# Access Compliance Report

## Public Rights-of-Way

Intersection ID: 14251	Main Street: CHESTERFIELD_AV	Cross Street: LORNA_ST	Location: N
ADA ID: D5F9DCE09055	Ramp Type: PerpDiag	Initial Pass/Fail: Fail	Overall Compliance: No
Severity Score: 12.5			
Codes/Mitigation Info/Possible Solution		Field Measurements/Component Compliance

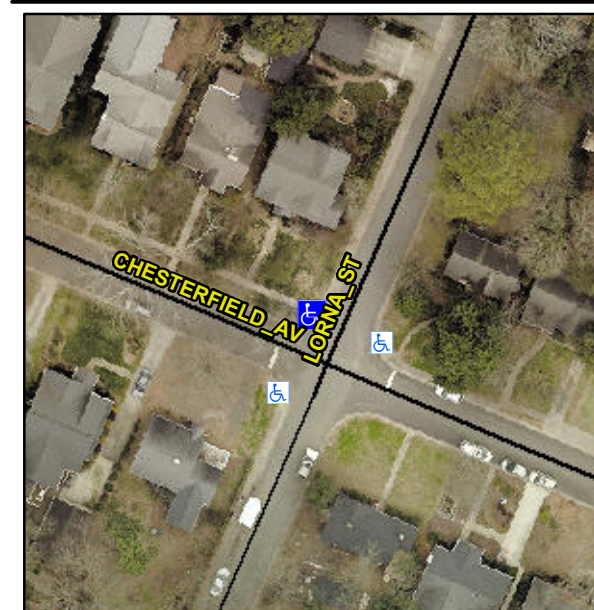
**Not Found, R304.2.2**

Compliance	Description	Data	Compliance	Description	Data
N/A	Ramp Length (in)	62.0	No	Ramp Slope (%)	8.7
Yes	Ramp Width (in)	87.0	Yes	Ramp XSlope (%)	0.4
N/A	Flare Type LT	N/A	N/A	Flare Type RT	N/A
N/A	Flare Slope LT (%)	N/A	N/A	Flare Slope RT (%)	N/A
N/A	Flare Traversable LT?	N/A	N/A	Flare Traversable RT?	N/A
N/A	Landing Length (in)	N/A	N/A	DWS Provided?	N/A
N/A	Landing Width (in)	N/A	N/A	DWS Contrast?	N/A
N/A	Landing Slope (%)	N/A	N/A	DWS Length (in)	N/A
N/A	Landing X Slope (%)	N/A	N/A	DWS Full Width?	N/A
N/A	Landing Curb? (Y/N)	N/A	N/A	DWS Offset (in)	N/A
N/A	Shared Landing?	N/A			
N/A	Gutter Ponding?	Yes	N/A	Gutter Slope (%)	N/A
N/A	Gutter Lip Ht (in)	N/A	N/A	Gutter X Slope (%)	N/A
N/A	Painted X Walk1?	No	N/A	Painted X Walk2?	No
	X Walk 1 Direction	To SW		X Walk 2 Direction	To SE
N/A	X Walk 1 Width (in)	N/A	N/A	X Walk 2 Width (in)	N/A
	X Walk 1 Slope (%)	5.0		X Walk 2 Slope (%)	3.9
	X Walk 1 X Slope (%)	1.2		X Walk 2 X Slope (%)	0.5

**Remove & Replace Curb Ramp With Two New Directional Ramps or Equivalent.**
